# Ordinary Meeting

**Tuesday, 9 September 2025**

Page
CL01 DA 82/2025 - Multi-dwelling Development consisting of Four (4) Two-Storey Dwellings	
(a) Attachment A - DA 82/2025 - Draft Conditions of Consent .....	3
(b) Attachment B - DA 82/2025 - DA Documents - 6 Antonio Place, Griffith .....	19
(c) Attachment C - DA 82/2025 - Redacted Submissions - 6 Antonio Place, Griffith.....	47
(d) Attachment D - DA 82/2025 - Development Assessment Report.....	64
CL02 Adoption of Local Policies - Tree Preservation Order, Tree Policy and Onsite Detention Policy	
(a) (PG-CP-401) Tree Preservation Order .....	92
(b) (PG-CP-402) Tree Policy.....	97
(c) (CS-CP-404) Onsite Detention Policy.....	112
Minutes of the Audit, Risk and Improvement Committee Meeting held on 20 August 2025	
(a) Draft Internal Audit TORs and Charter - Review August 2025 .....	124

Development consent has been granted for multi-dwelling housing development with four (4) two-storey dwellings at LOT: 31 DP: 1083401 6 Antonio Place GRIFFITH.

SHADOW DIAGRAM  
3:00 P.M.  
21st JUNE..

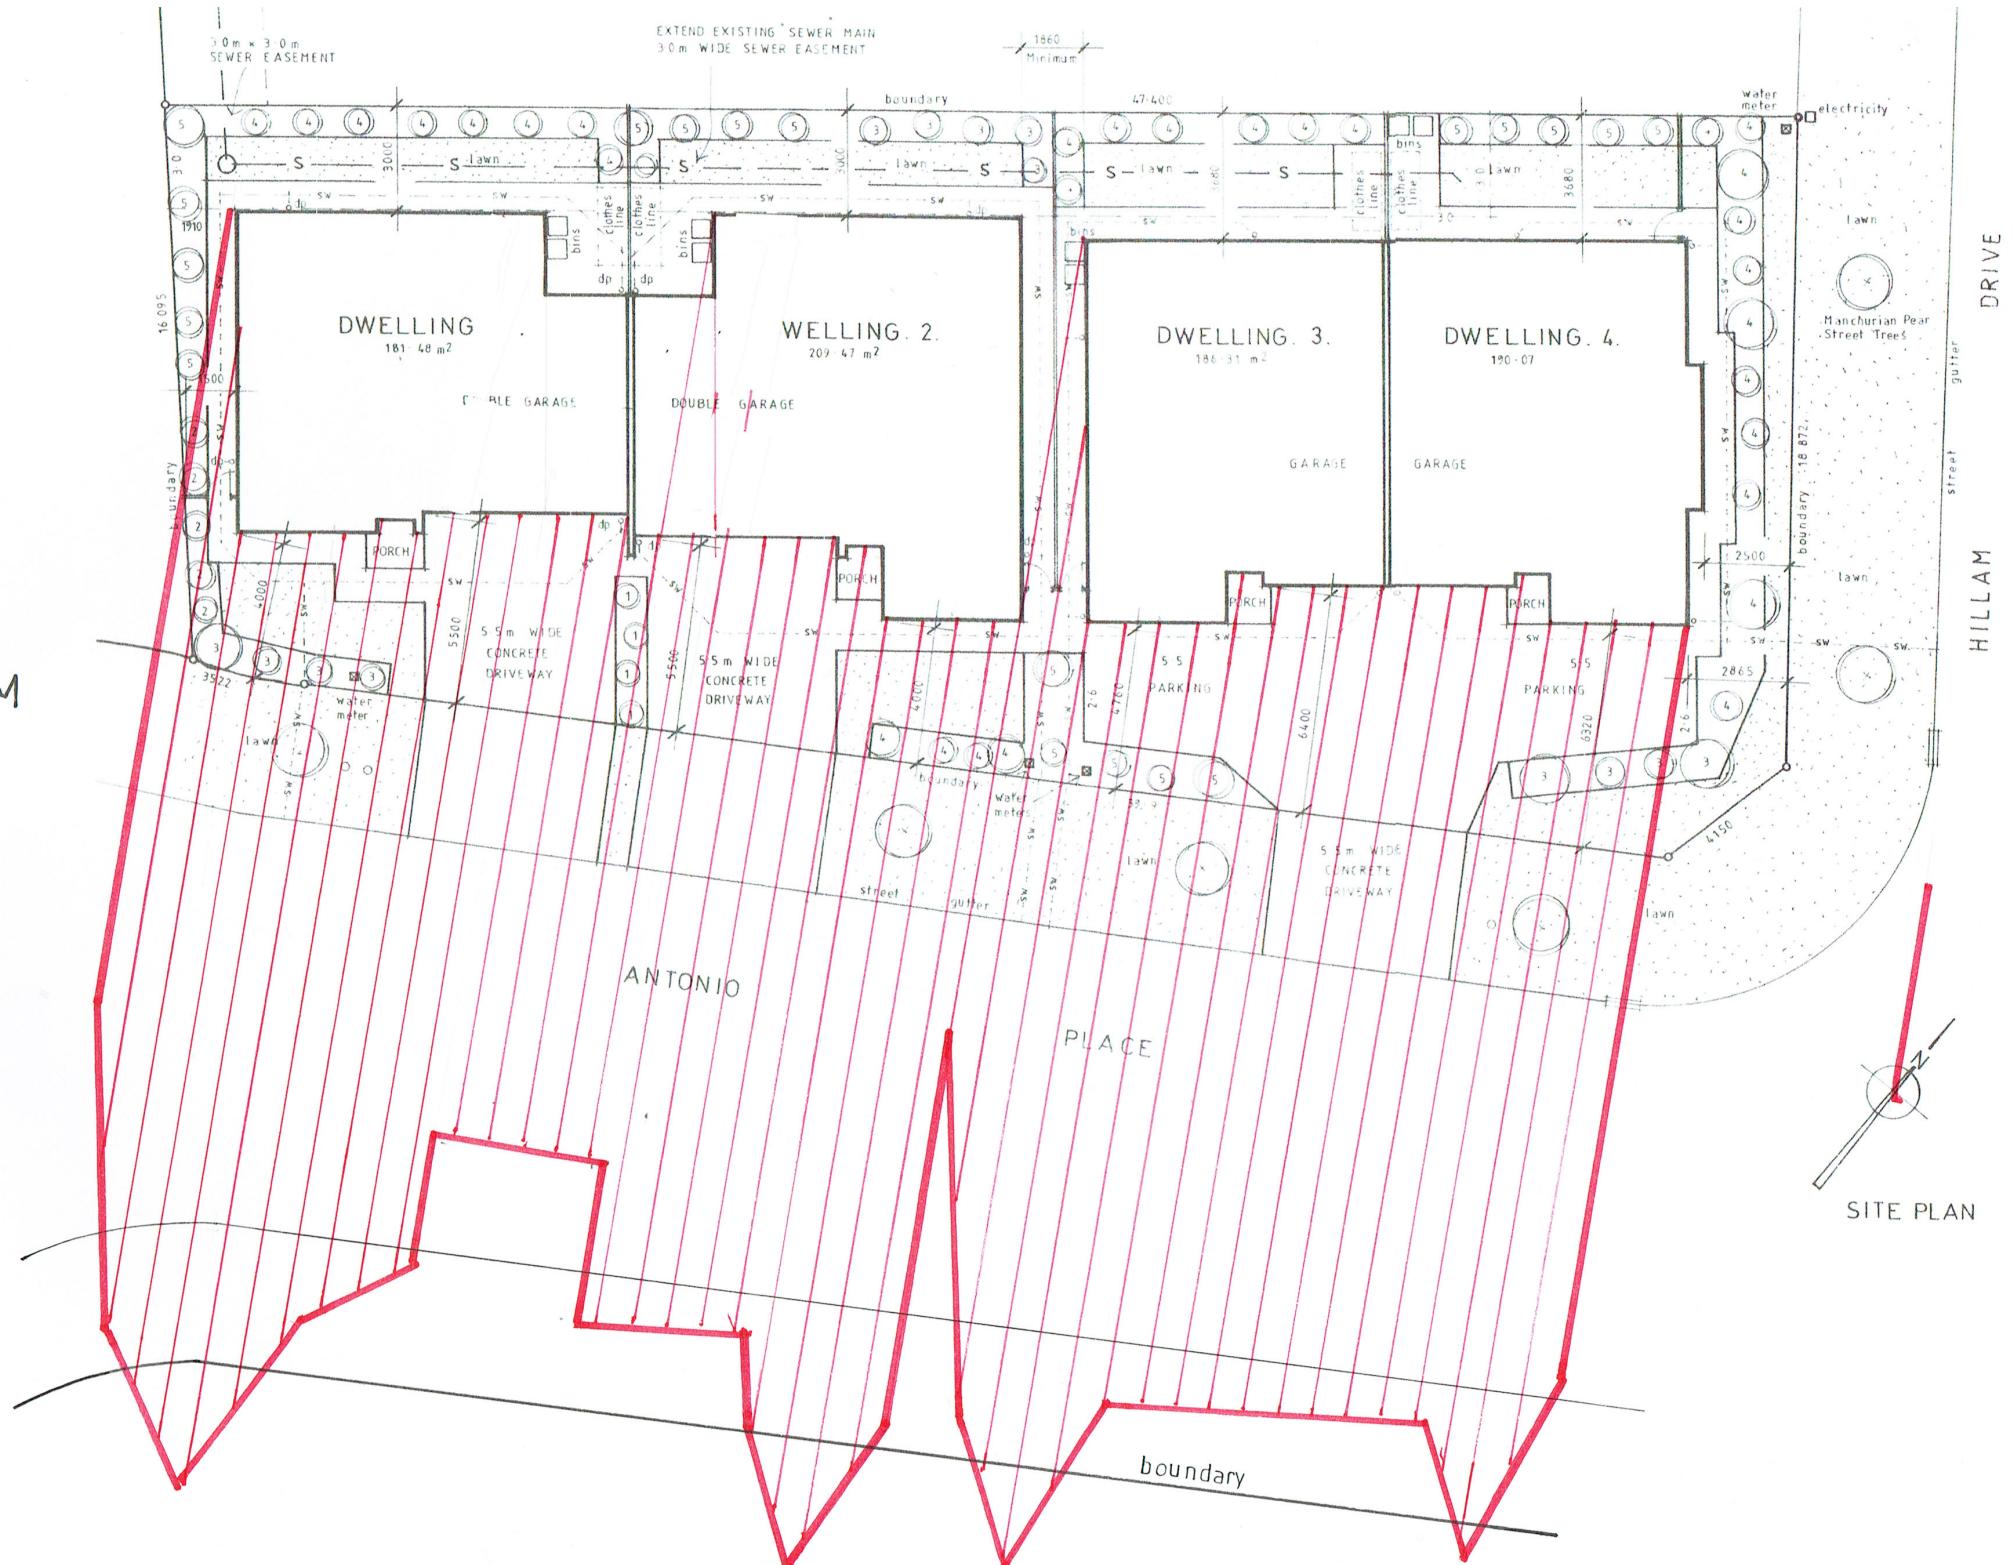
Excessive shadowing and loss of sunlight - The proposed development will significantly increase overshadowing in the street. In accordance with the supplied shadow plans, at 9am, the shadowing could potentially impact upon my property. However, this is difficult to assess as the shadow plans do not show adjoining properties. The shadowing will have a significant impact upon the next-door property. Their entire front yard will be completely shaded, starving their plants and front lawn from the winter sun. By 3pm, the entirety of the entry to our street is cast in shadow. Additional structures of this scale will reduce visibility and light access, and detracting from the peaceful and sunny atmosphere our neighbourhood enjoys. The development will block the street view of Scenic Hill, an aesthetic appeal of the street and Collina area.

I respectfully request the shadow plans are resubmit, showing the buildings within the cul-de-sac. Vehicle access within the cul-de-sac - Positioning of vehicle access within the cul-de-sac will exacerbate safety concerns for pedestrians and existing residents, particularly during peak hours. The narrowness of the road poses significant risks when multiple vehicles are entering and exiting simultaneously, especially for families with young children or elderly residents.
